Title of Document:	Request for Change	Issue No. G26-04955	Rev. 0
Customer:		Issue date: September 3, 2026	
Title subject:	PA Connector: Appearance Change	Revision date:

We would like to request your approval for the change in appearance of the gold-plated areas of the PA connector.

PA Connector SMT Type Header

Photo 2: Front view

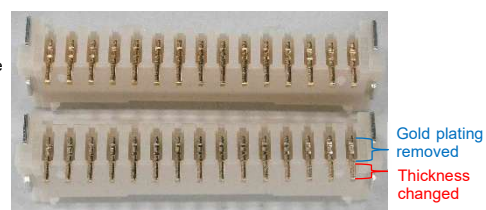
For the above-mentioned products, gold plating will be removed from areas where gold plating is not required for product performance. The part numbers shown on the product labels, product specifications, and drawings will remain unchanged. <For appearance details, see Photos 1 to 3.>
